OIL INDIA LIMITED
(A Government of India Enterprise)
P.O. Duliajan, Pin – 786602
Dist-Dibrugarh, Assam

Addendum No. 5 Dated 17.09.2015
to
IFB No. CDG7573P16

This Addendum No. 5 dated 17.09.2015 to IFB No. **CDG7573P16** for Hiring the Services of 10(ten) sets of Electrical Submersible Pump (ESP) system on rental basis including Operation & Maintenance (O&M) for a period of 3(three) years, extendable by another 1(one) year is issued to notify the clarification/reply of queries of different bidders and also to notify extension of the Sale Date & Bid Closing / Technical Bid Opening date as under:

Reply of Queries of Different Bidders

COMPLETE WELLHEAD EQUIPMENT DETAILS

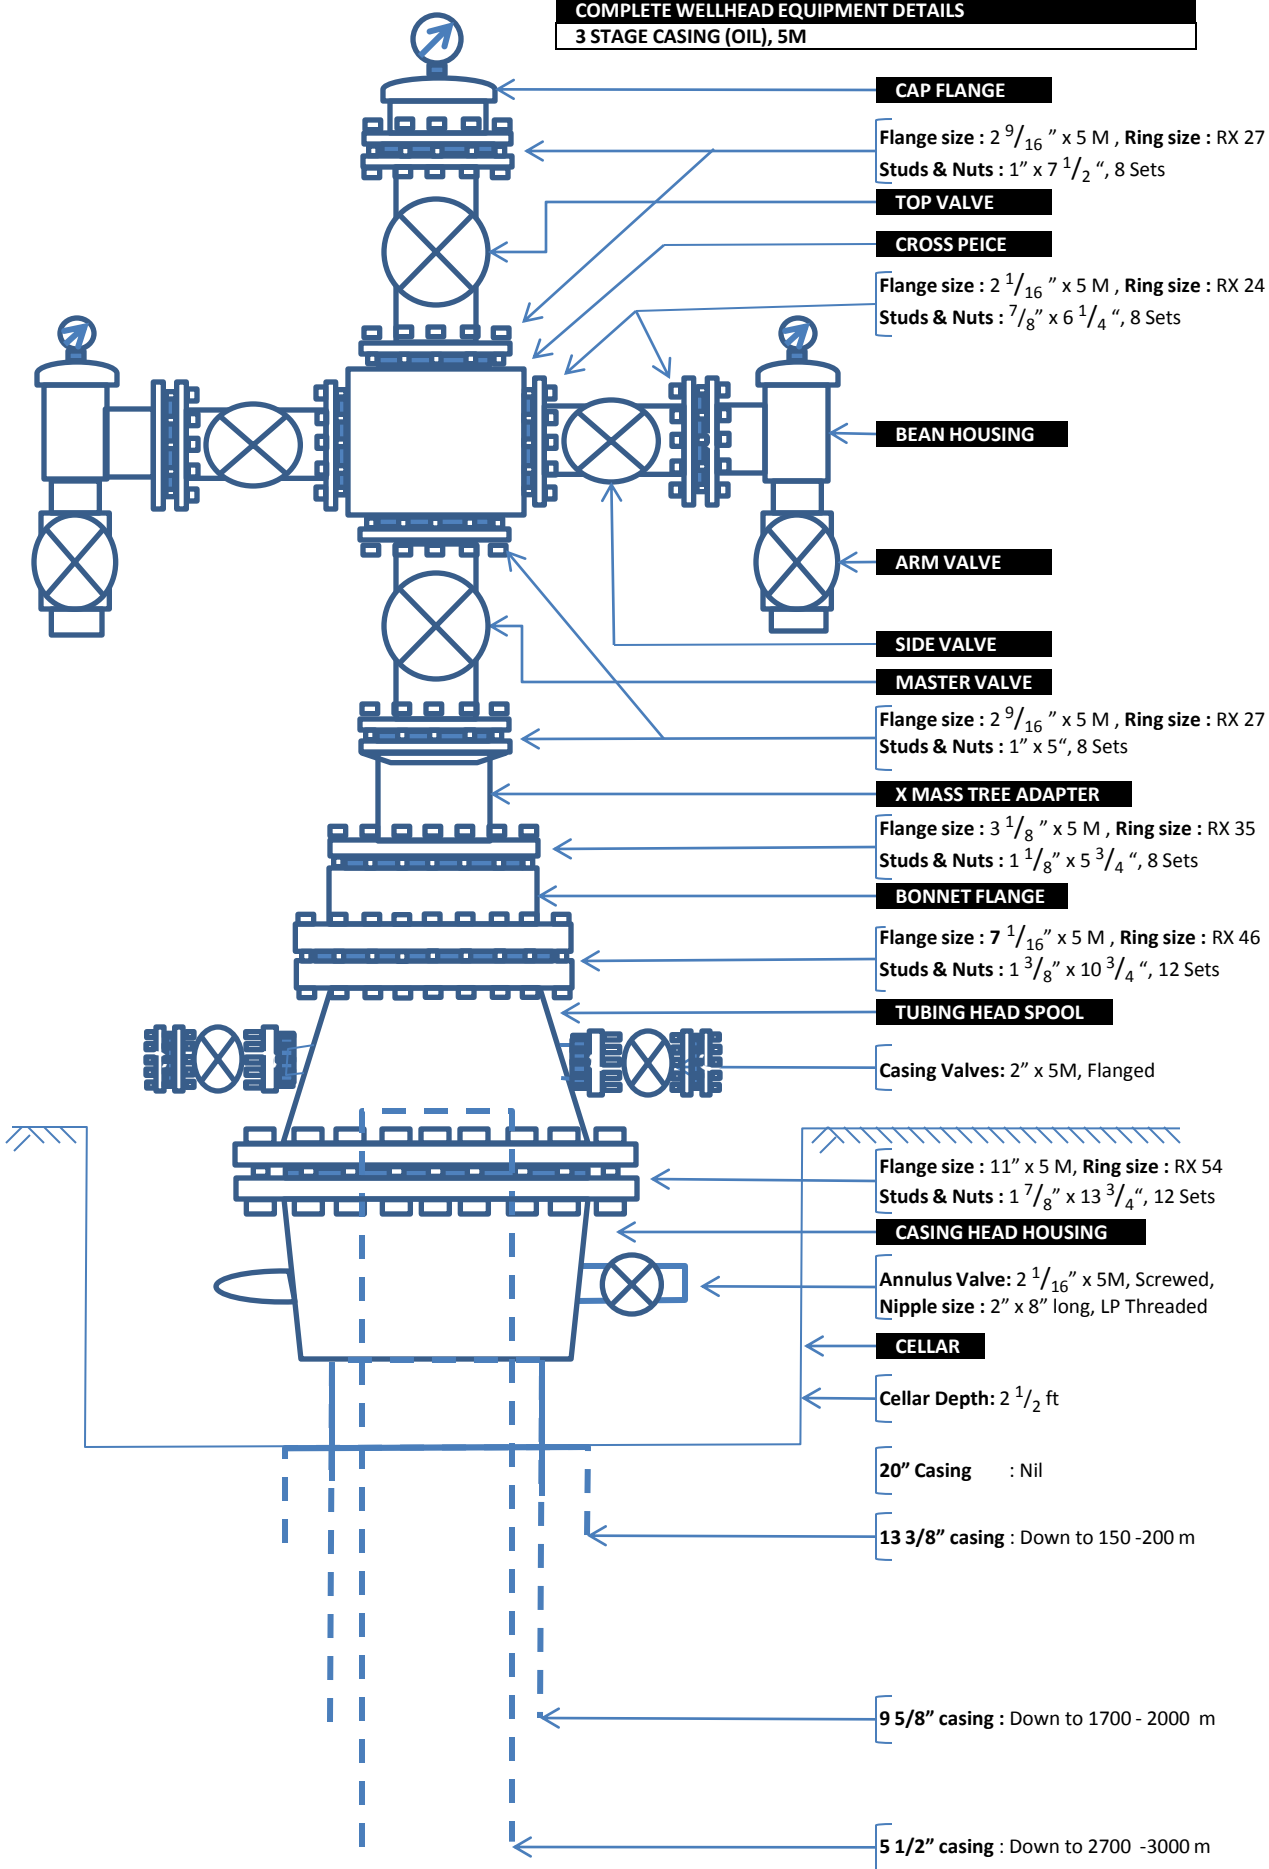
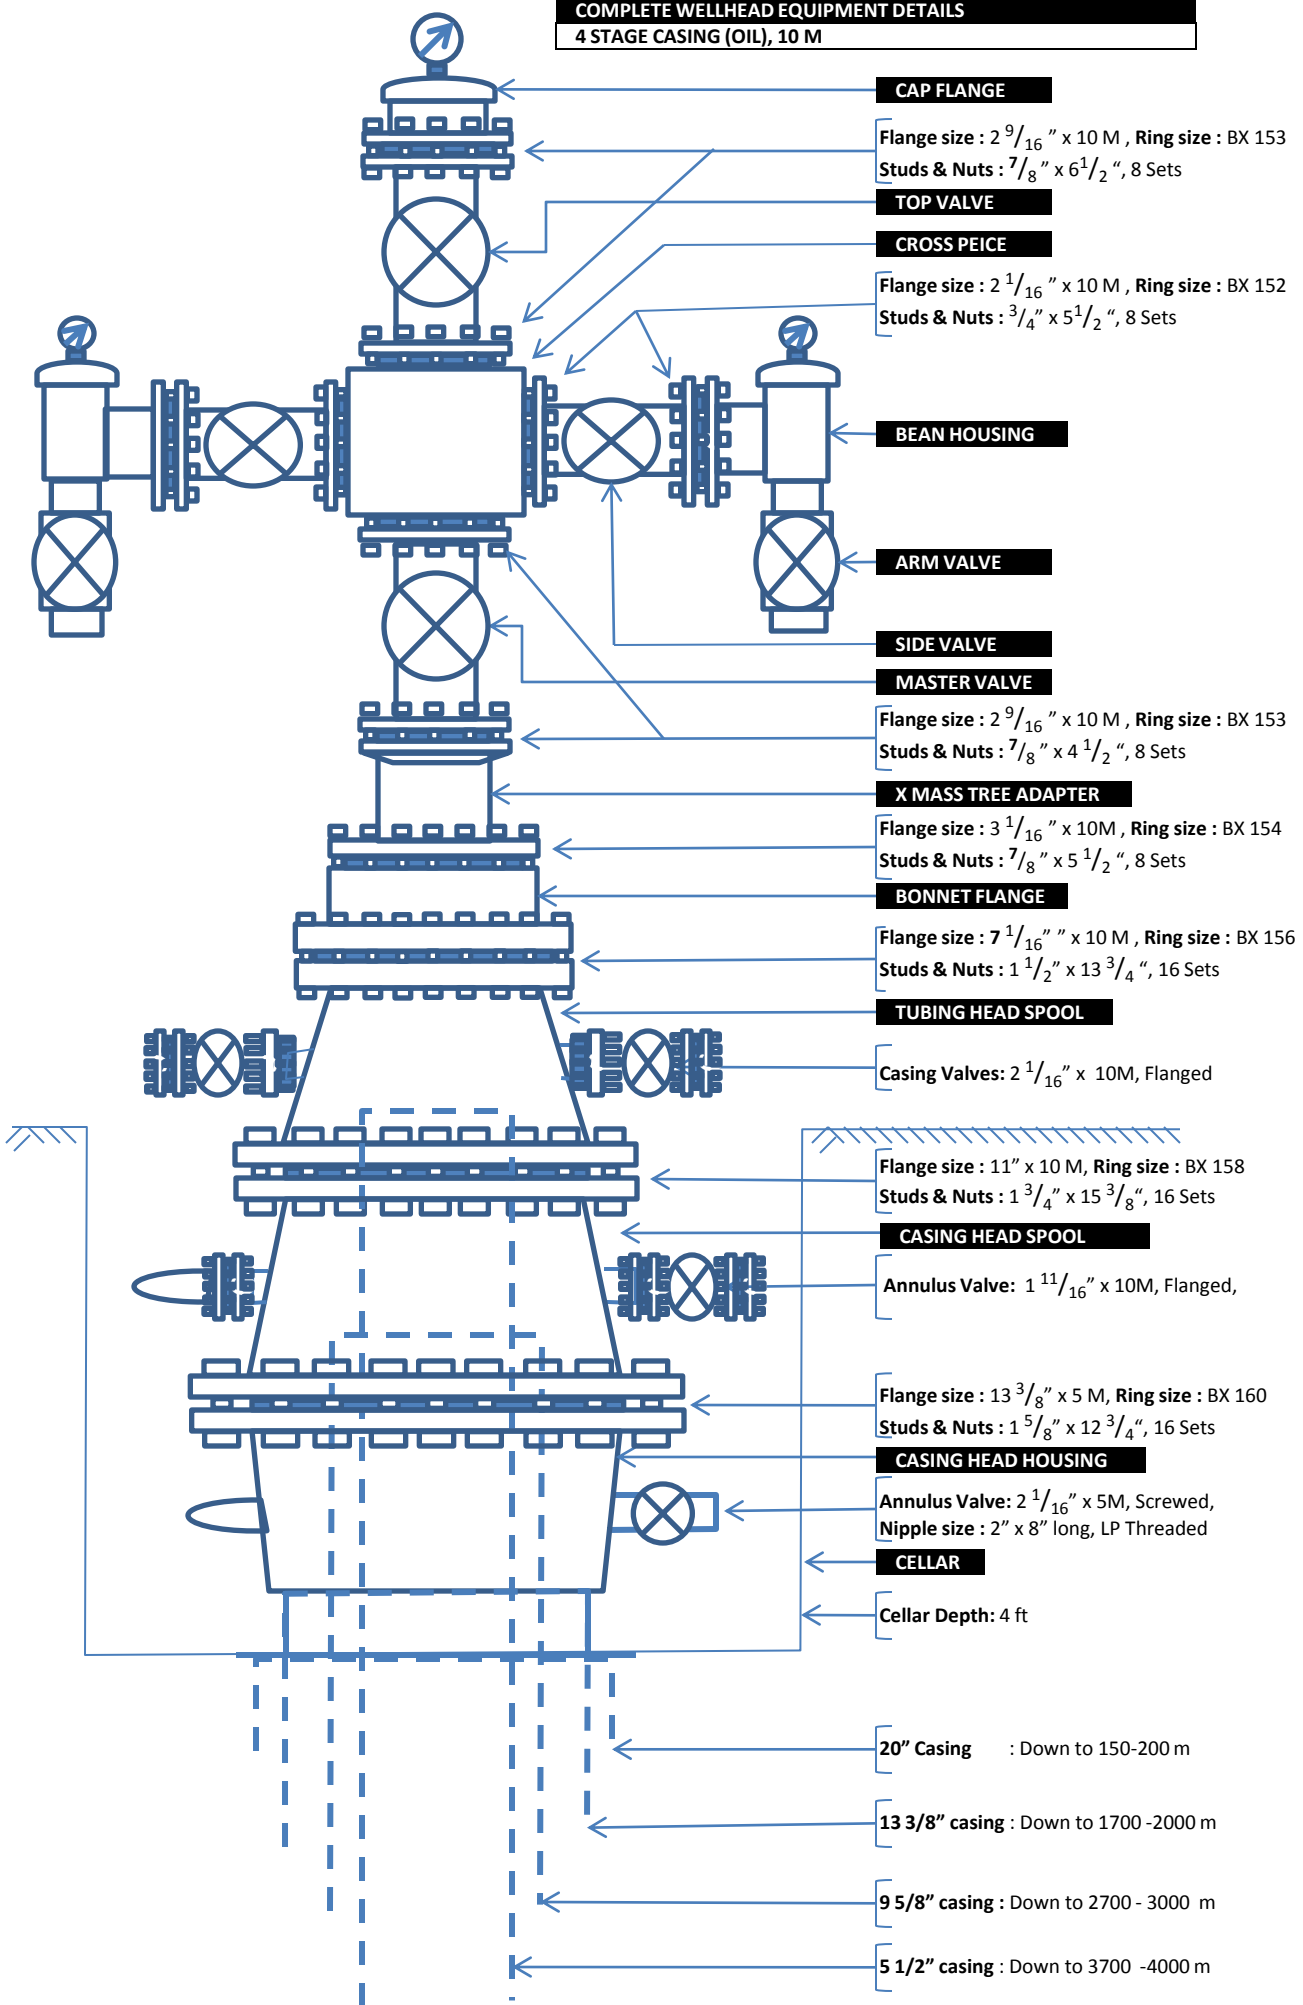
40		4. As page 51 mentions well head we assume that this is a Contractor's responsibility to supply the same. In this case please provide any technical data/drawings relevant to the current well head design.		Drawing is attached.
41		Kindly refer to Liquidated Damages (Clause 17 page of general terms) 1. Kindly change the LD to 1/2% of the total value of 2 ESP system subject to a maximum of 5% .		Not accepted. No Change.
42		Kindly refer-Under Part-3, Section-II, sub section E- Installation and Commissioning of ESP 1. It is mentioned HSD shall be supplied by		1. Please be guided as per clause no. E of Part 3 Section 2 of tender.
